COUNCIL SUPPLEMENTARY ASSESSMENT REPORT

SYDNEY EASTERN CITY PLANNING PANEL

PANEL REFERENCE & DA NUMBER	PPSSEC-316 DA-2024/56 PAN-413901
PROPOSAL	Amended – Concept Development Application – Consolidation of lots (including road), demolition of existing structures, tree removal, construction of commercial development comprising of five (5) towers (with plant) above a podium with a maximum total gross floor area of 48 645sqm, 400 car parking spaces and associated landscaping.
ADDRESS	No's 7-9, 14-16, 18-21 Chalmers Crescent (Lots 11-26 inclusive DP 29697) and the eastern part of Chalmers Crescent containing the cul-de-sac turning bulb (Lot 1 DP 1260420).
APPLICANT	The Trustee for F Mayer Imports Superannuation Plan
OWNER	The Trustee for F Mayer Imports Superannuation Plan
DA LODGEMENT DATE	15 April 2024
APPLICATION TYPE	Concept Development Application
REGIONALLY SIGNIFICANT CRITERIA	Clause 2.19, Schedule 6 of <i>State Environmental Planning Policy (Planning Systems) 2021</i> states that any development with an estimated development cost over \$30,000,000 is classified as Regionally Significant Development.

Figure 1 – East Elevation Envelope

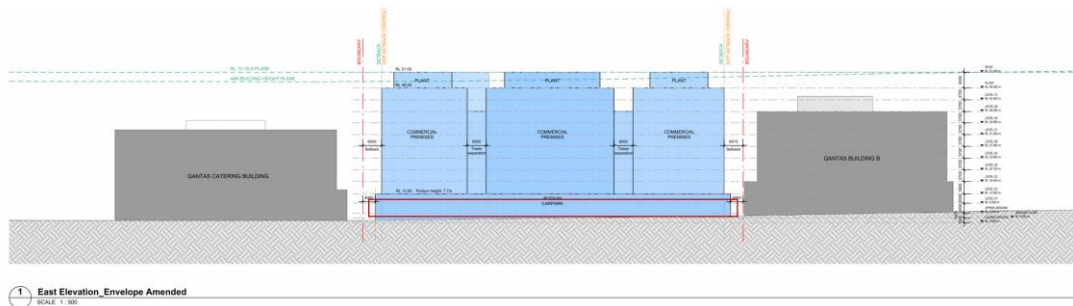
A reduction in parking to 400 spaces could be achieved by deleting the upper ground podium level carparking, which currently accommodates 165 car spaces and provide some articulation to the other car parking levels by design changes. See Figure 1–5 below, which identifies the level that could be removed.

Importantly, the removal of this floor would result in the reduction of overall height, bulk, mass, and scale of the built form, thereby bringing the proposal into compliance with the height development standard.
